Model: R – C5 One-bin Tray		Date: 14-Jun-10	No.: RD367001
Subject: Guide Plate		Prepared by: T. Nihei	
From: 1st Overseas Tech Support Sec., 1st PQM Dept.			
Classification:	<input checked="" type="checkbox"/> Troubleshooting <input type="checkbox"/> Part information <input type="checkbox"/> Action required <input type="checkbox"/> Mechanical <input type="checkbox"/> Electrical <input type="checkbox"/> Service manual revision <input type="checkbox"/> Paper path <input type="checkbox"/> Transmit/receive <input type="checkbox"/> Retrofit information <input type="checkbox"/> Product Safety <input type="checkbox"/> Other ()

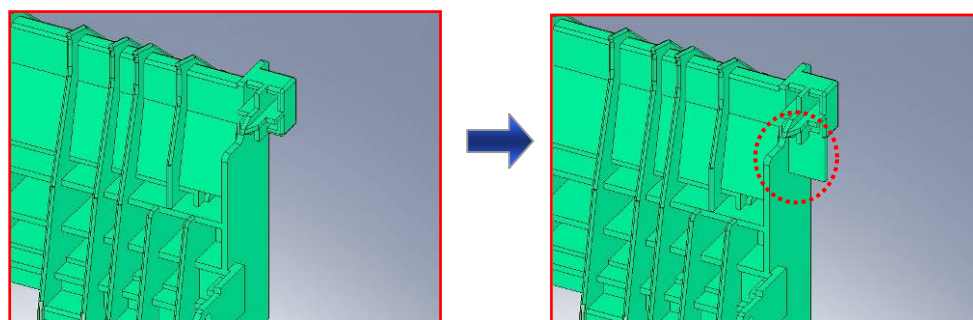
Change: The shape of the guide plate was changed.

Reason: To ensure that the separation guide plate does not interfere with the movement of the fusing pressure release lever.

Old part number	New part number	Description	Q'ty	Int	Page	Index	Note
D3674164	D3674165	GUIDE PLATE - GATE	1-1	X/O	3	21
